MODEL
3.5RL
3.2TL

BULLETIN NO.
99-038

Safety Recall: Extension Shaft Sealing Bolt

(Supersedes 99-038, dated August 19, 1999)

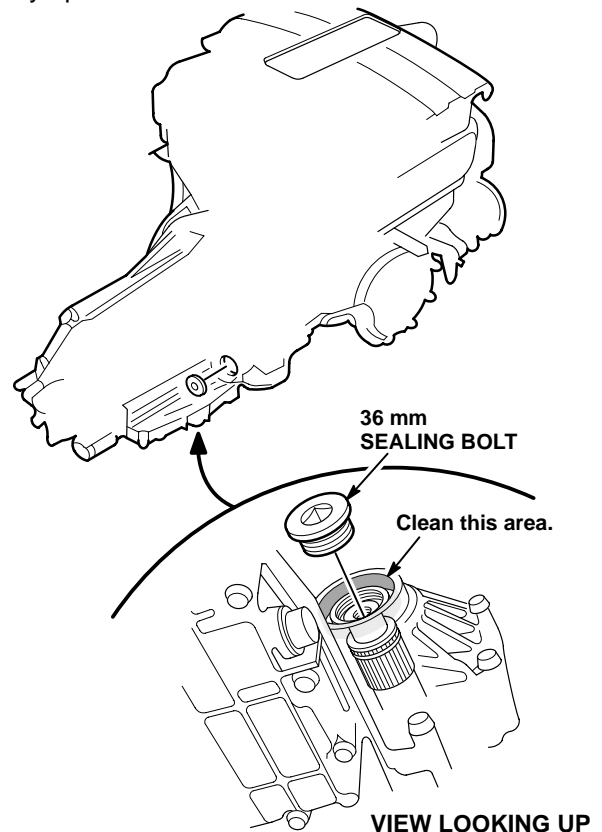
The 36 mm sealing bolt on the side of the transmission housing may loosen and fall out. If this occurs, the extension shaft may back out and disconnect from the differential. If this happens while driving, the car loses power to the drive wheels without warning. If the car is stopped with the transmission in Park and the parking brake not engaged, the car could move unexpectedly.

Replace and properly torque the 36 mm sealing bolt.

1. Make sure the vehicle is in Park, then raise the vehicle on a hoist.
2. Use brake cleaner and compressed air to clean the area around the 36 mm sealing bolt. Wear eye protection.

3. Remove the 36 mm sealing bolt.
4. Use brake cleaner and compressed air to clean the threads in the transmission housing. Wear eye protection.
5. Install the O-ring on the new sealing bolt.
6. Install the new 36 mm sealing bolt. Do not use any thread lock or thread sealer. Torque the bolt to 78 N·m (58 lb-ft).
7. Lower the vehicle.
8. Center-punch a completion mark above the fifth character (A) of the engine compartment VIN.
